ELECTRICAL POWER - WIRE BUNDLE ASSEMBLY (WBA) CLAMP AND ANCHOR MODIFICATION

700 (Citation Longitude)

SB700-24-01
Page 1 of 4

Figure 1. Wire Bundle Assembly Clamp Removal/Installation (Sheet 1)

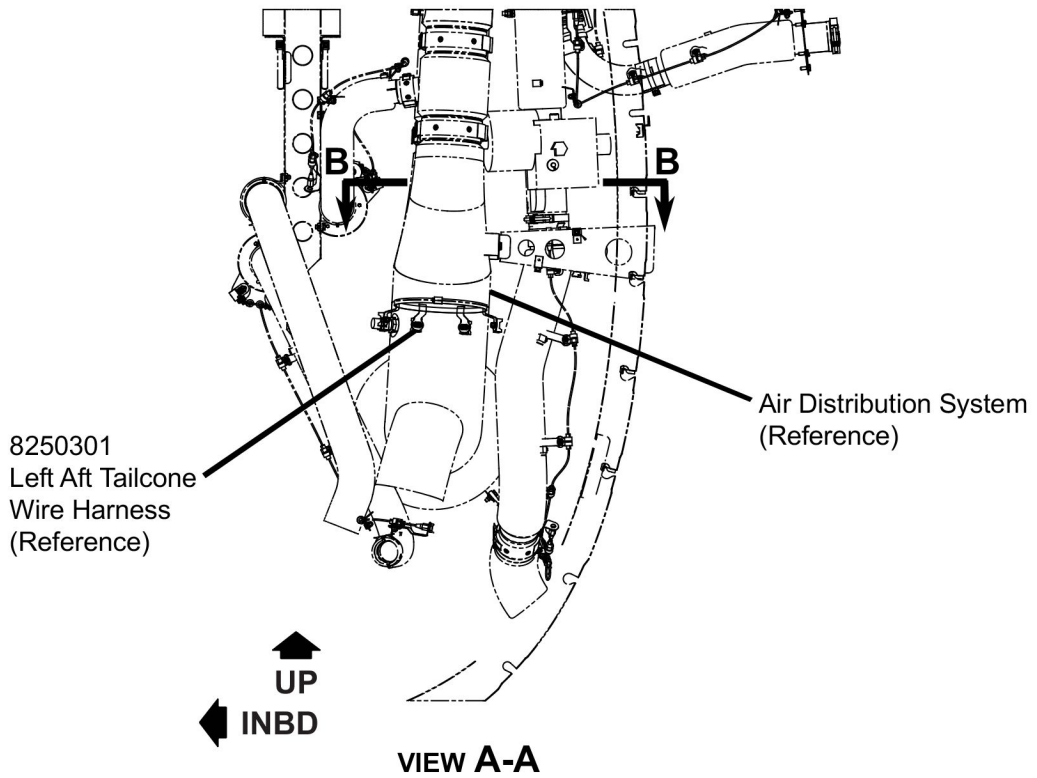
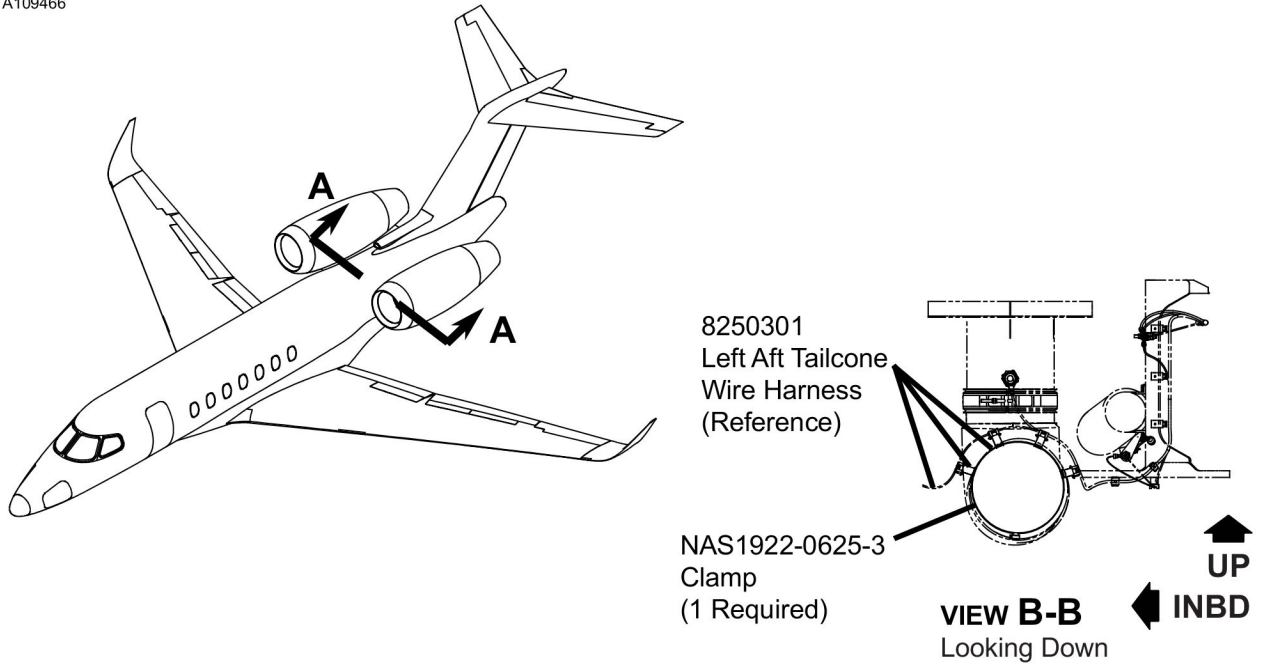
The current wire bundle assembly clamp does not tighten.

3. (Refer to Figure 1, View A-A and View B-B.) Install a new NAS1922-0625-3 Clamp that attaches to the 8250301 Left Aft Tailcone Wire Harness to the air distribution system.

- A. Remove the 8250301 Left Aft Tailcone Wire Harness from the NAS1922-0700-3 Clamp.
 - B. Remove and discard the NAS1922-0700-3 Clamp from the air distribution system.

- C. Install the new NAS1922-0625-3 on the air distribution system.
4. Remove the maintenance warning tags and connect the airplane batteries.
5. Close the tailcone access door. (Refer to the Model 700 Maintenance Manual, Chapter 6, Dimensions and Areas - Description and Operation.)
